Stage 1 Road Safety Audit and Designers Response

**BLYTHE INDUSTRIAL ESTATE,
CRESWELL, STAFFORDSHIRE**

Proposed Highway Works

**Stage 1 Road Safety Audit
Requested by Motion**

Cresswell Road Footway and
Localised Highway Widening

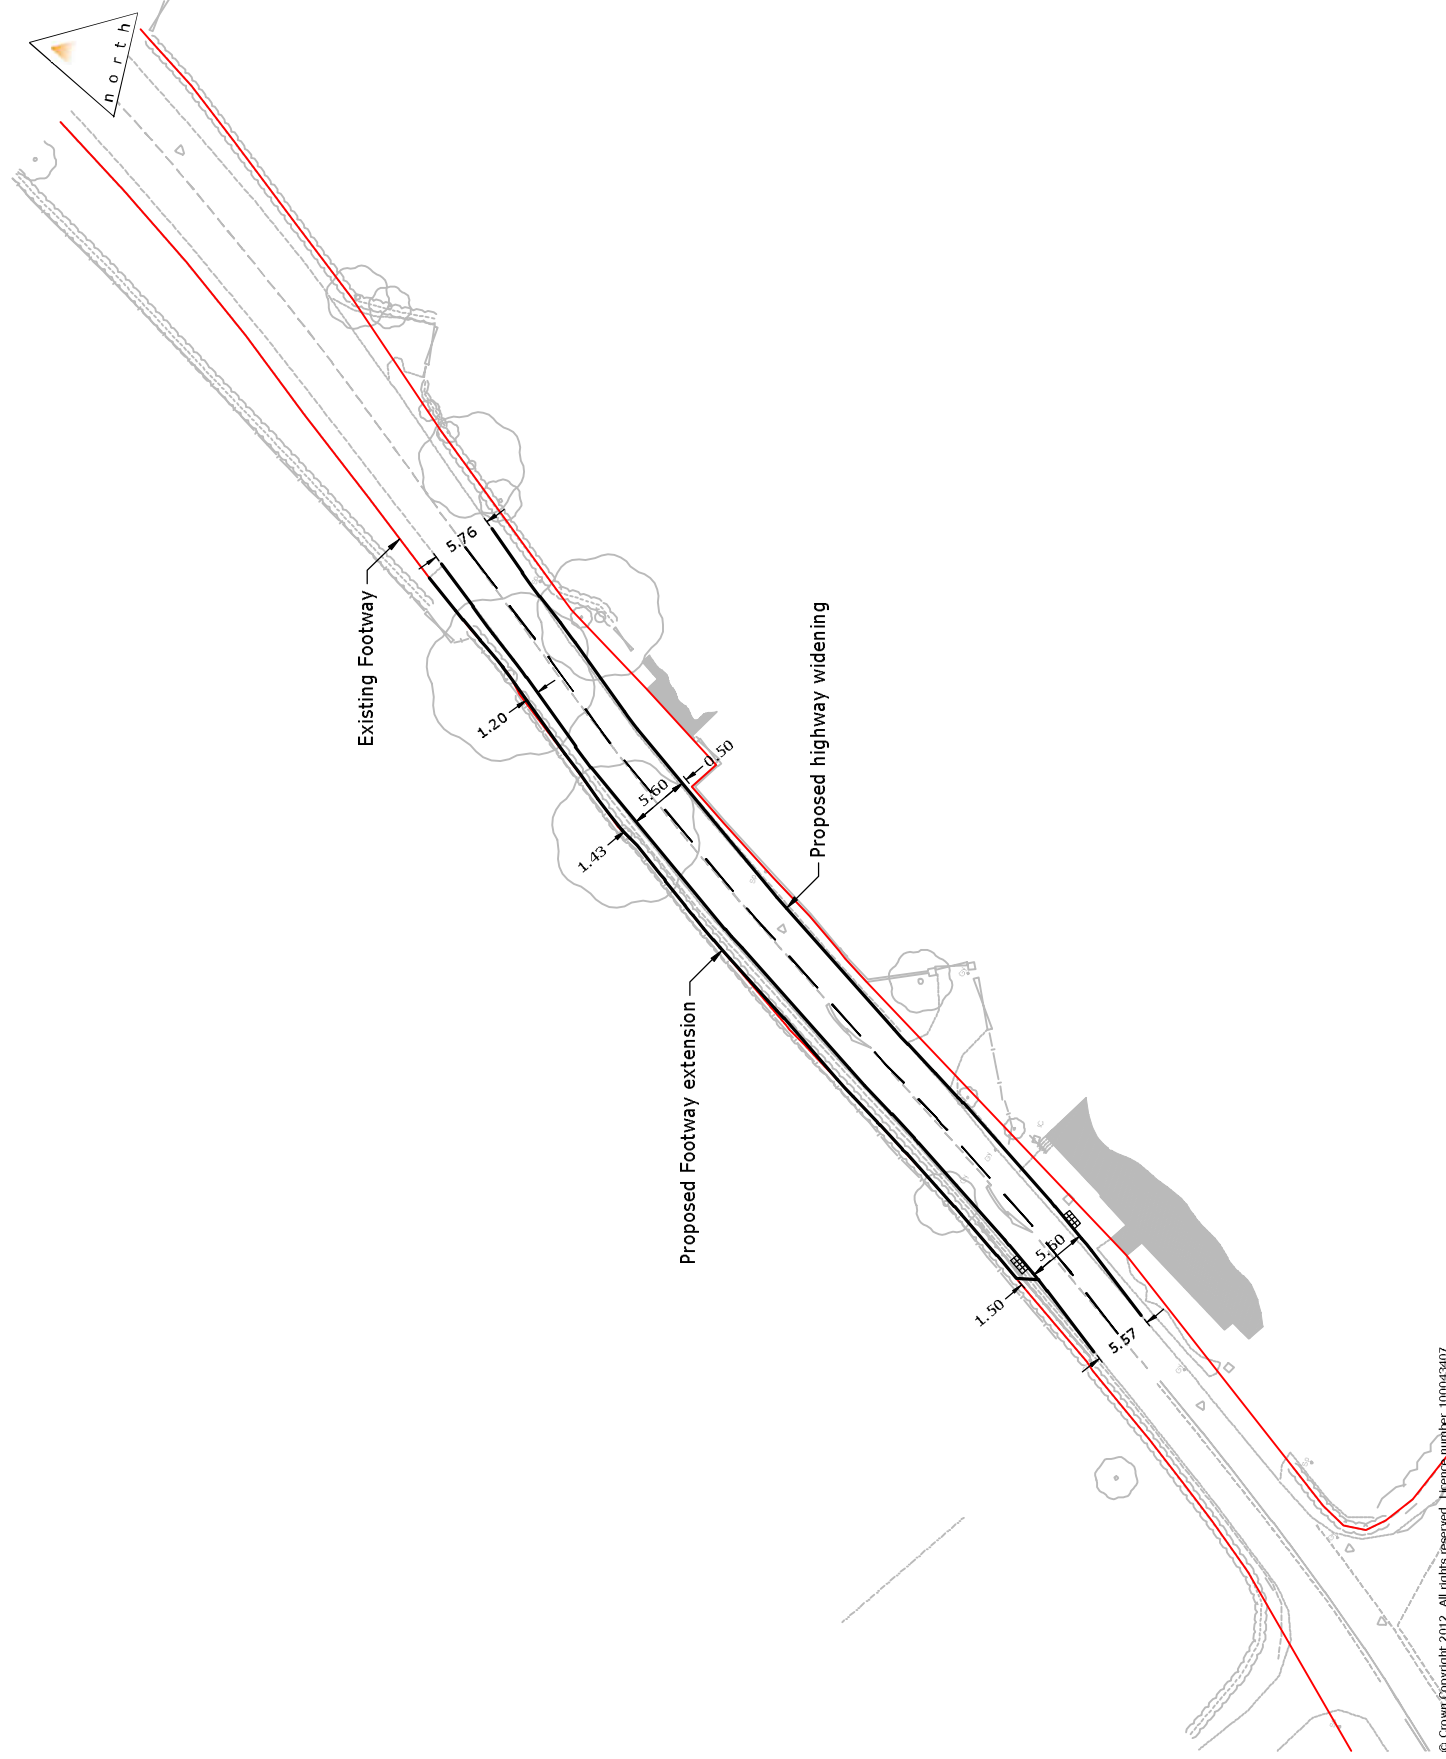
Item No.	Audit Team Comments	Audit Team Recommendation(s)
3.5	Comment: Potential conflicts due to restricted visibility Location: <i>Cresswell Road/ Sandon Road/Proposed Site Access roundabout</i> Description: The proposed roundabout results in the realignment of Cresswell Road and Sandon Road to facilitate the proposed site access. Existing foliage along the eastern side of Cresswell Road and Sandon Road adjacent to the proposed site access may restrict visibility. Inadequate visibility could lead to collisions between vehicles entering the roundabout from the proposed site access and those entering from Cresswell Road and Sandon Road.	Confirm that the existing foliage along the eastern verge of Cresswell Road will be removed or cut back in order to maximise visibility for traffic entering the roundabout from the proposed roundabout.

3.5	Confirm that the existing foliage along the eastern verge of Cresswell Road will be removed or cut back in order to maximise visibility for traffic entering the roundabout from the proposed roundabout.	It is confirmed that existing vegetation within the public highway and/or the land that is controlled by the client will be cut back/removed as necessary in order to maximise visibility.

Project:	Blyth Industrial Estate
Title:	Suggested Roundabout Arrangement
Scale:	1:500 (@ A3)
Drawing:	120314-04
Revision:	C

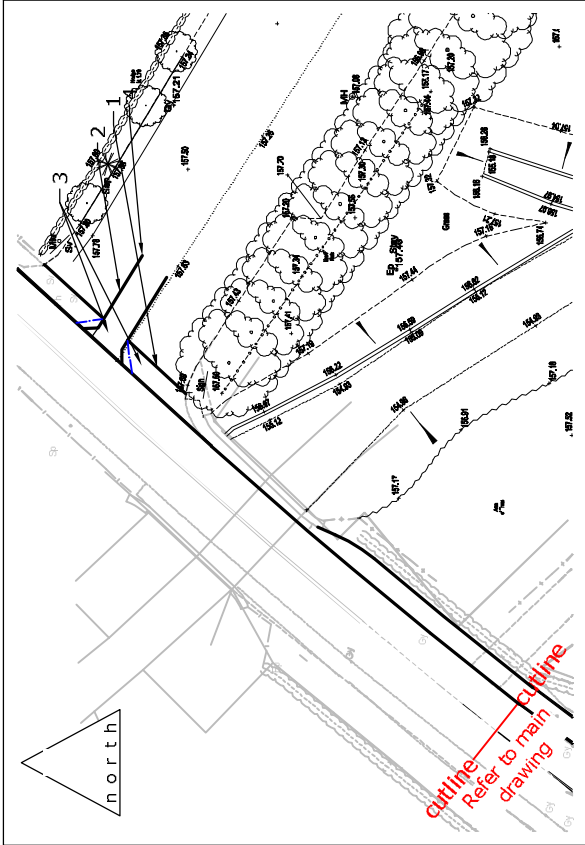
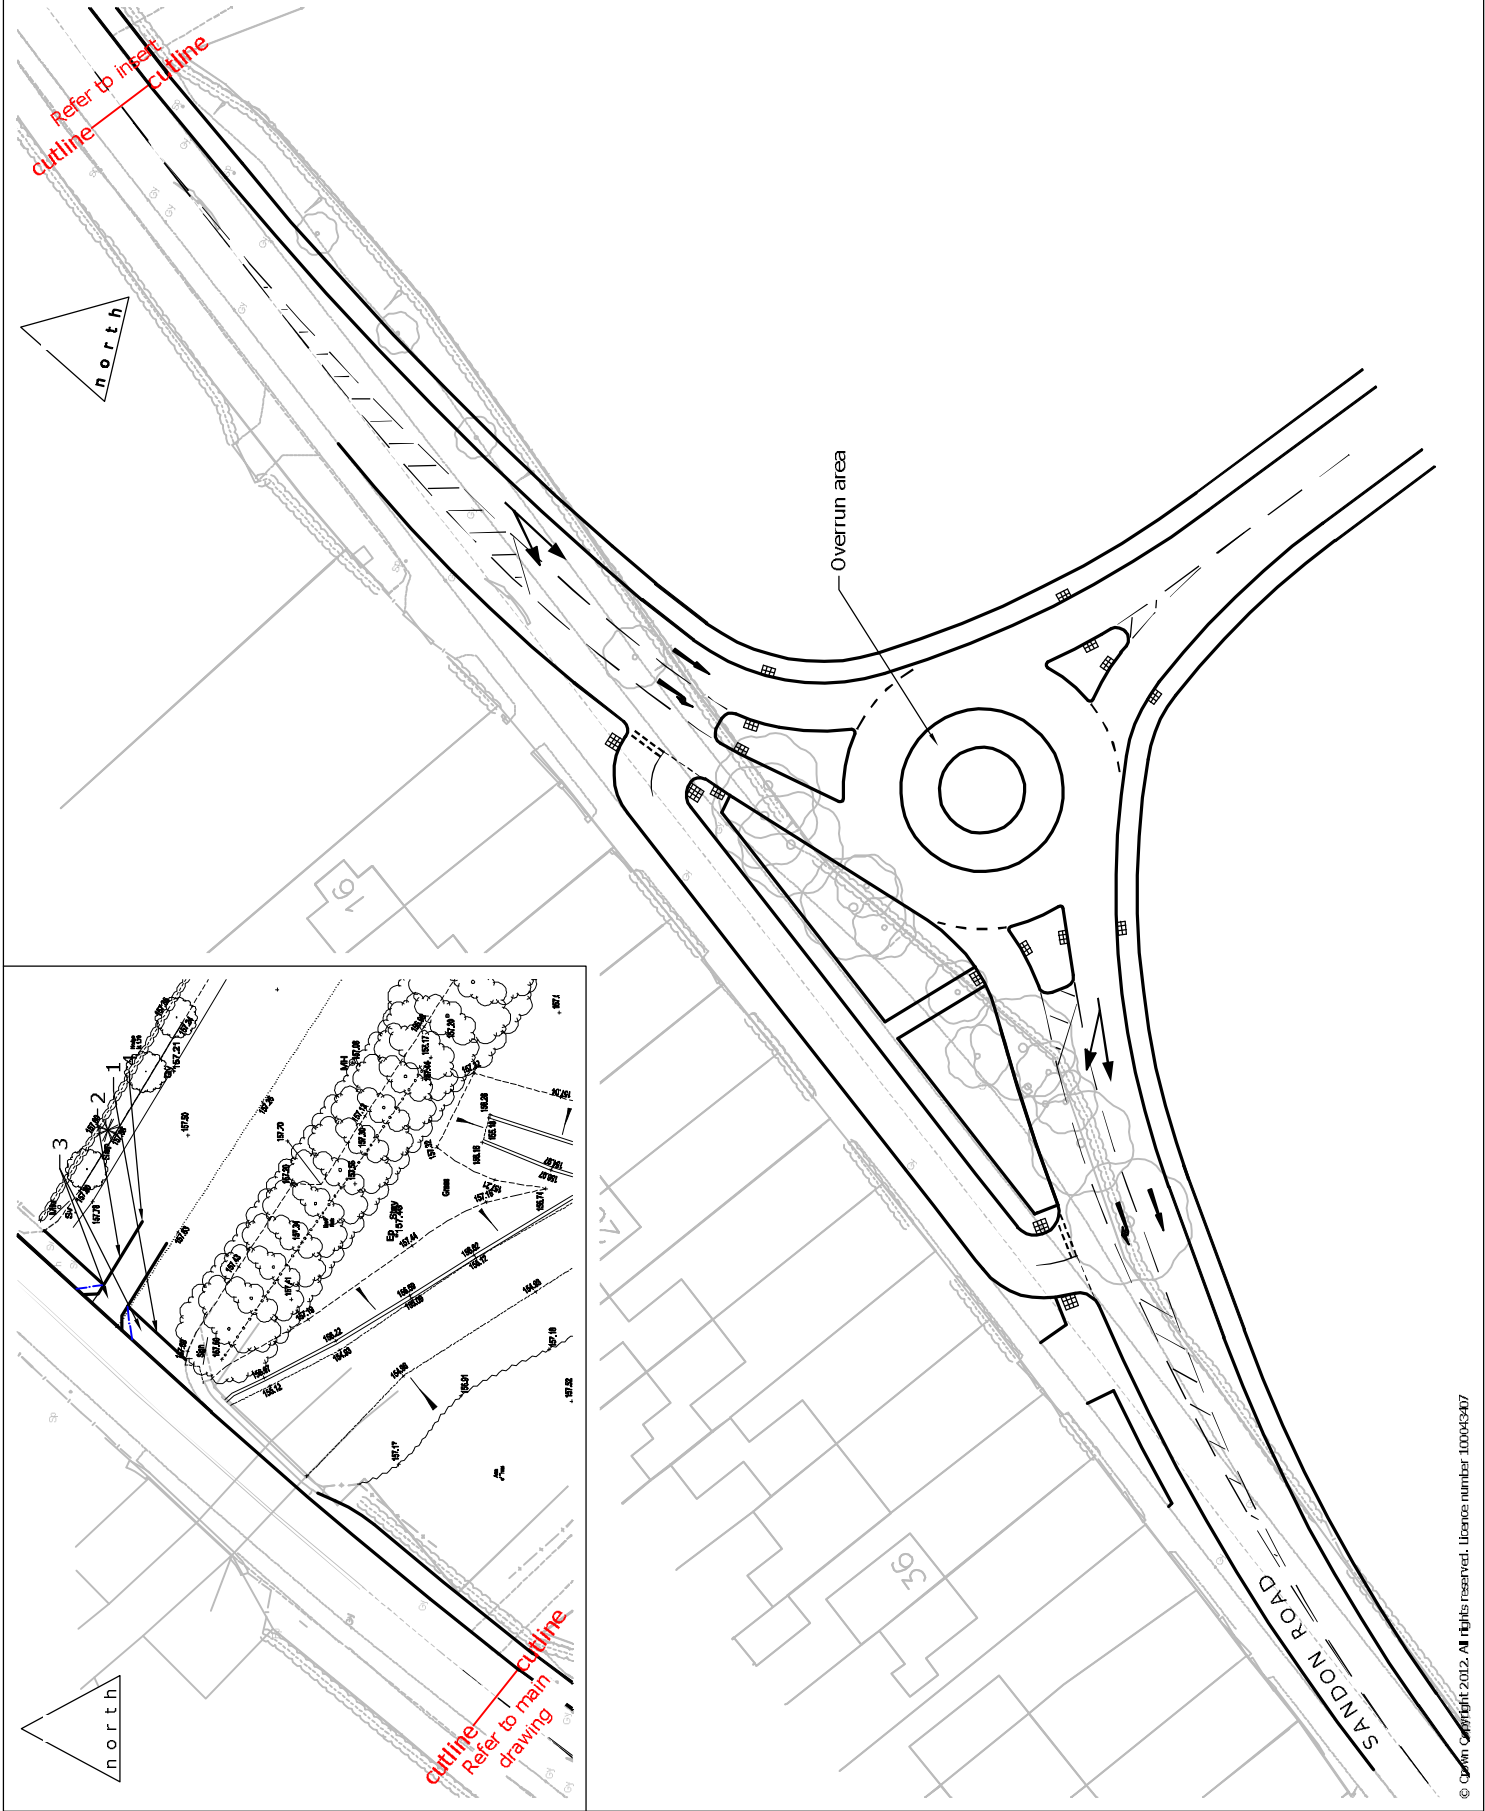
3.7	Pedestrian crossing facilities should be provided at the proposed roundabouts, including dropped kerbs and tactile paving.	Agreed. Drawing 130104-04 has been amended to show pedestrian crossing points and to illustrate a continuous footway on the south side of Cresswell Road between the proposed vehicular access and the existing bridge that cross the River Blithe. A new pedestrian/cycle/emergency access is now also shown in the existing access. Please refer to Drawing 130104-04c. Drawing 130104-08a has also been updated to show pedestrian facilities. The updated drawings are attached to this Designer's Response. Please refer to Drawing 130104-08b.

Project:	Blyth Industrial Estate
Title:	Suggested Roundabout Arrangement
Scale:	1:500 (@ A3)
Drawing:	120314-08
Revision:	B

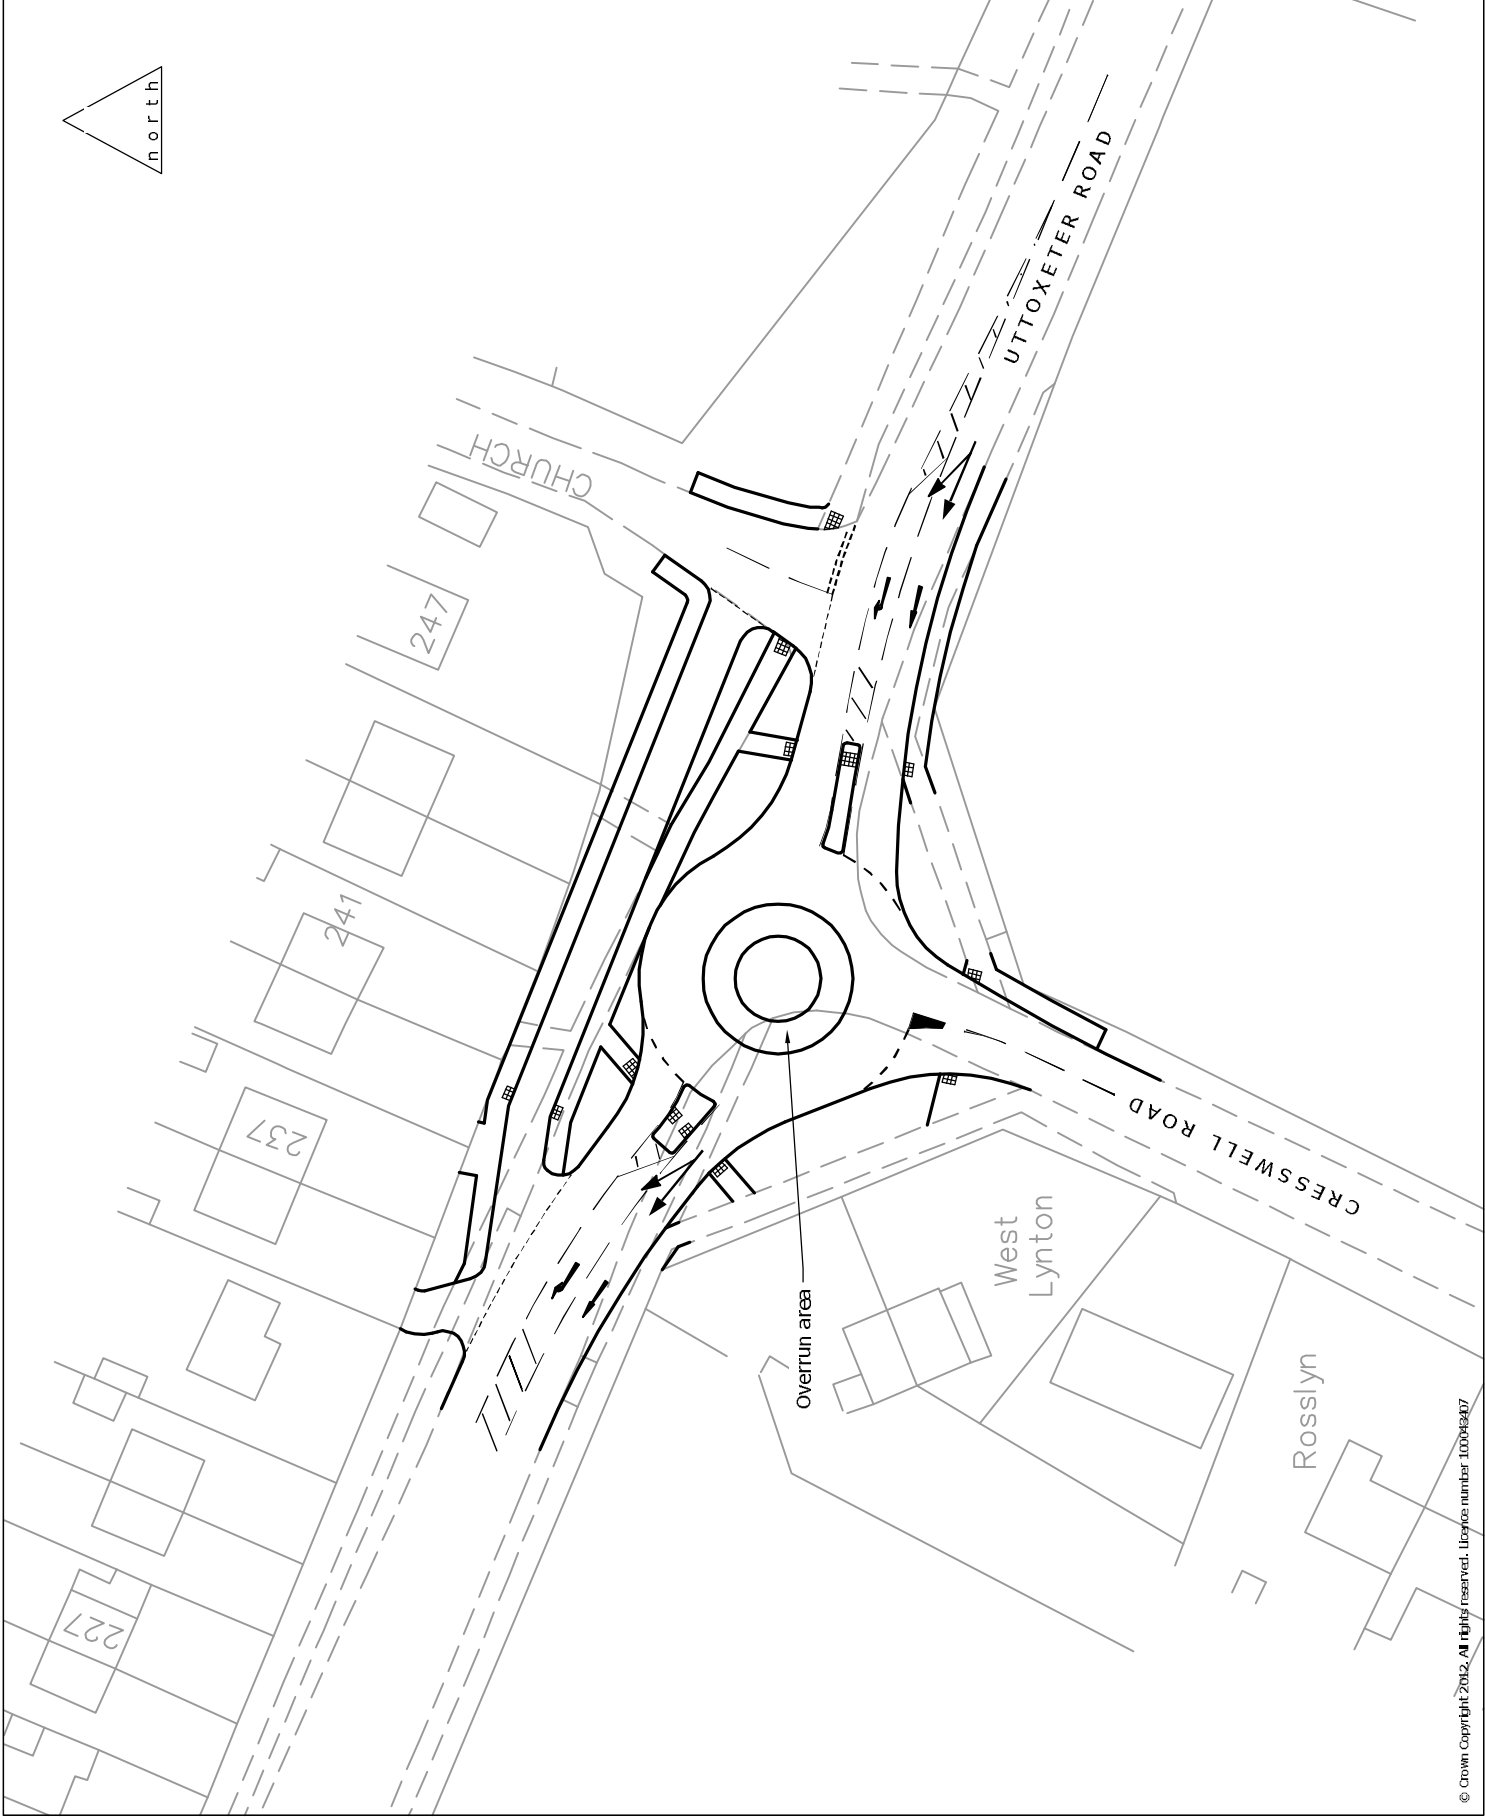
3.4	Comment: Potential conflicts due to restricted visibility <i>Uttoxeter Road/Cresswell Road roundabout</i> Description: The realignment of Uttoxeter Road to facilitate the proposed roundabout results in the give way line on Cresswell Road being set back. It is not entirely clear whether or not adequate visibility from Cresswell Road will be available. Inadequate visibility may lead to collisions between vehicles entering the roundabout from Cresswell Road and those entering from Uttoxeter Road.	Confirm that the existing foliage along Uttoxeter Road southern verge on its approach to the roundabout will be removed or cut back in order to maximise visibility from Cresswell Road.

Item No.	Audit Team Comments	Audit Team Recommendation(s)
Checklist A4 – Non-motorized User Provision		
3.7	Comment: Provision for pedestrians Location: <i>Proposed roundabouts</i> Description: No details have been provided relating to pedestrian crossing facilities at the proposed roundabout. The absence of pedestrian crossing facilities may encourage pedestrians to cross the roundabout at locations where it is unsafe, thereby increasing the risk of collisions with passing vehicles.	Pedestrian crossing facilities should be provided at the proposed roundabouts, including dropped kerbs and tactile paving.

3.4	Confirm that the existing foliage along Uttoxeter Road southern verge on its approach to the roundabout will be removed or cut back in order to maximise visibility from Cresswell Road.	It is confirmed that existing vegetation within the public highway will be cut back/removed as necessary in order to maximise visibility.
